REQUEST

Current Zoning: R-22MF (multifamily residential)
Proposed Zoning: UR-2(CD) (urban residential, conditional)

Approximately 8.862 acres located on the south side of West Boulevard, the west side of Beech Nut Road, and east of Clanton Road.

The petition proposes to allow a multi-family residential development on a vacant parcel located in West Charlotte.

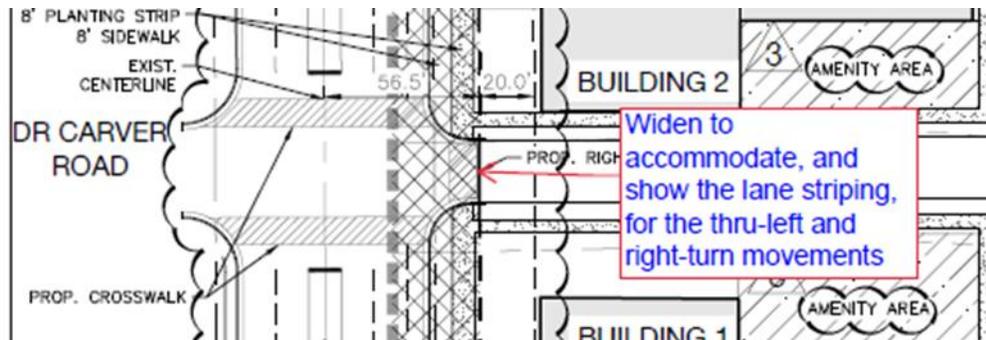
7. ~~Revise the site plan and conditional notes by providing a designated right turn lane on Public Road 1, to turn onto eastbound West Boulevard, and a combined through/left turn lane to cross West Boulevard or to turn onto eastbound West Boulevard. Please show lane striping on Public Road 1. Include turn lane striping as well. The turn lane striping still needs to be shown even though the site layout has changed. Not Addressed~~ **Addressed**

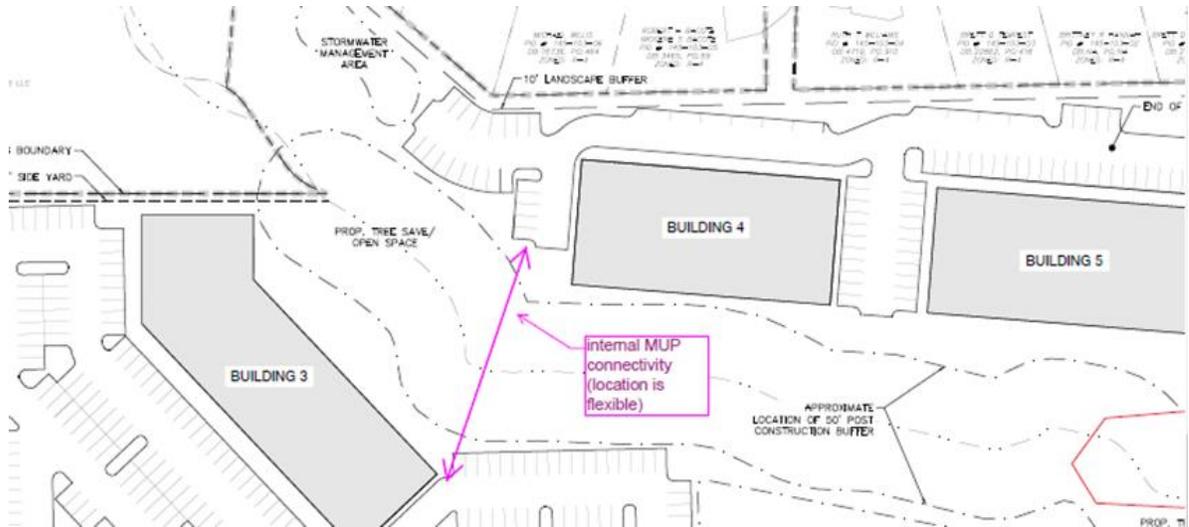
~~**Update to Comment (03-23-2021 Site Plan):** Revise the site plan and conditional notes to commit to widen, and show the appropriate lane striping, for the aforementioned turning movements on Private Access Drive, formerly "Public Road 1" at the West Blvd./Dr. Carver Intersection. Not Addressed~~ **Addressed**

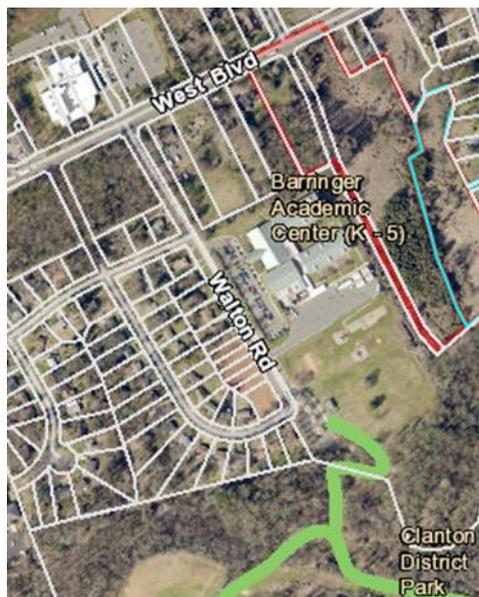
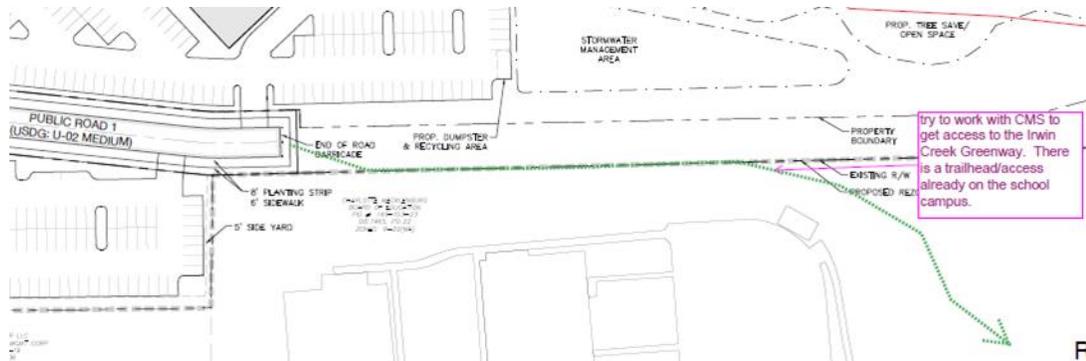
8. ~~Revise the site plan and conditional notes by committing to the construction of an internal, 12-foot wide, shared-use path to connect the development area for proposed Buildings 4 and 5 to the development area for proposed Buildings 1, 2, and 3. Update to Comment as a result of the 01-12-2021 Site Plan: Comment addressed with additional vehicular connection between building areas. Not Addressed~~ **Addressed**

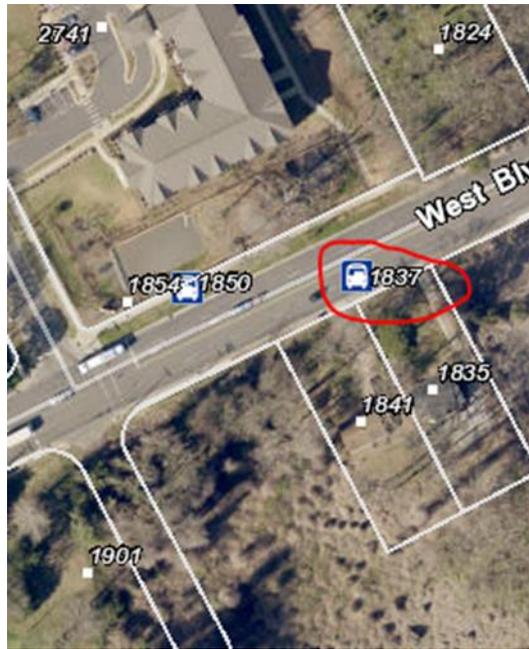
- 9. ~~Revise the site plan and conditional notes by committing to coordinate with Charlotte-Mecklenburg Schools (CMS) to provide a pedestrian connection/access to the Irwin Creek Greenway. The ICG currently has a trailhead located within the adjacent property of the Berringer Academic Center. Include the conditional note to coordinate with CMS to make the connection to the Irwin Creek Greenway Trailhead.~~ **Addressed**

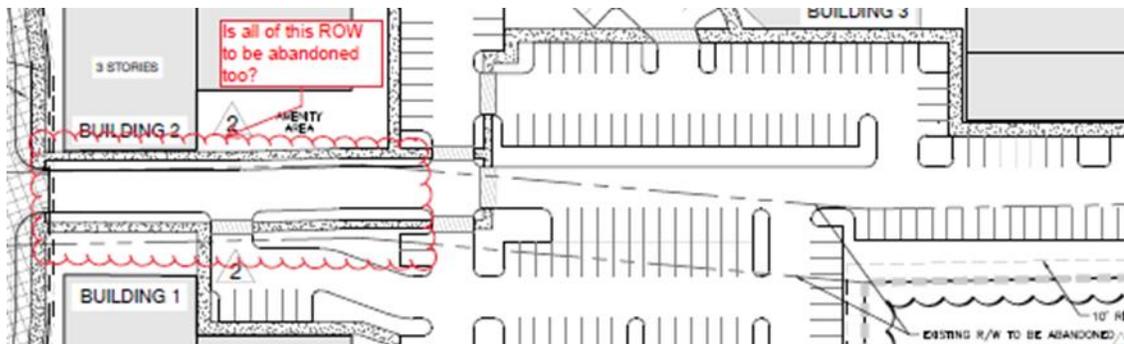
- 11. A site plan note(s) specifying dedication and fee simple conveyance of all rights of way to the City before the site's first building certificate of occupancy is issued is needed. CDOT requests rights-of-way set at 2' behind back of sidewalk where feasible. **Addressed**
- 12. A site plan note specifying that all transportation improvements will be approved and constructed before the site's first building certificate of occupancy is issued is needed. The petitioner may phase transportation improvements if said improvements and phasing are explicitly described in site plan notes. **Addressed**
- 13. Revise the site plan and conditional notes to commit to restriping the existing crosswalk, the Dr. Carver/Public Road 1 and West Boulevard intersection, in addition to the turn lane and signal improvements. **Addressed**

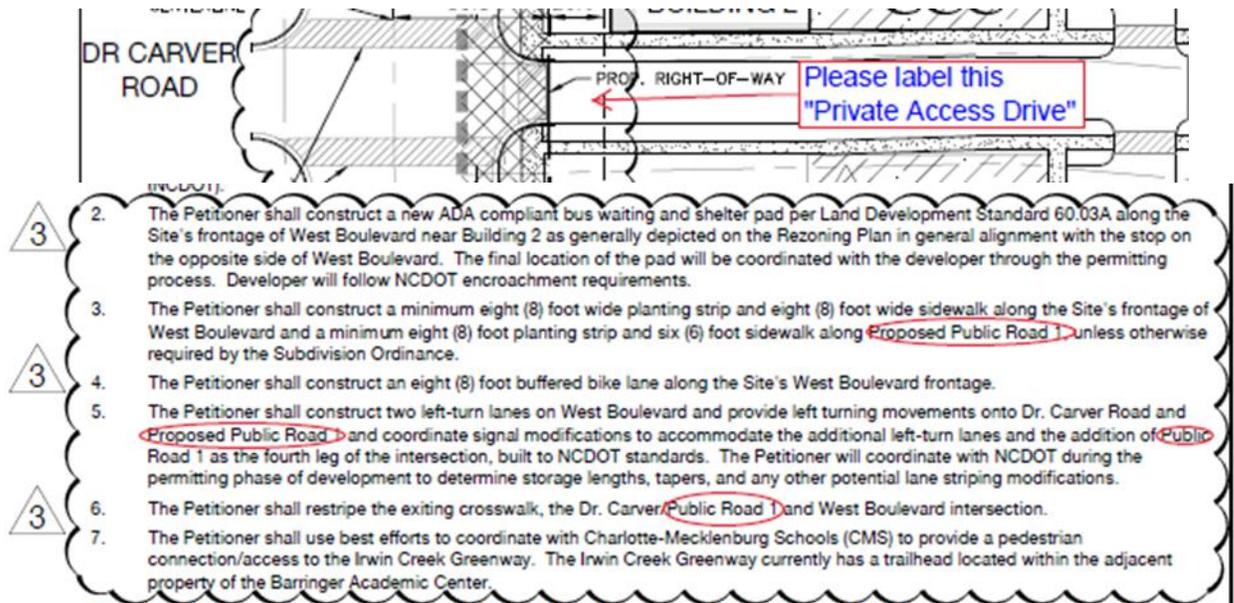
- 15. **New Comment (03/23/2021 Site Plan):** Revise the site plan by renaming Public Road 1 to "Private Access Drive". Additionally, revise each relative conditional note by changing "Public Road

1" to "Private Access Drive". Lastly, since all public roads have been removed, revise the conditional notes by removing any references to "Public Road 1". **Addressed**

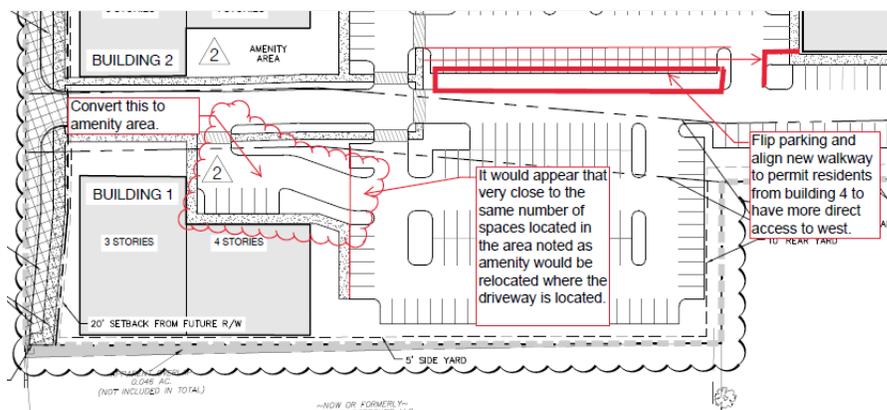
- 16. ~~Revise site plan to clearly show that the R-4 portion is not part of the rezoning. Ensure rezoning boundary clearly differentiates this information. Addressed~~
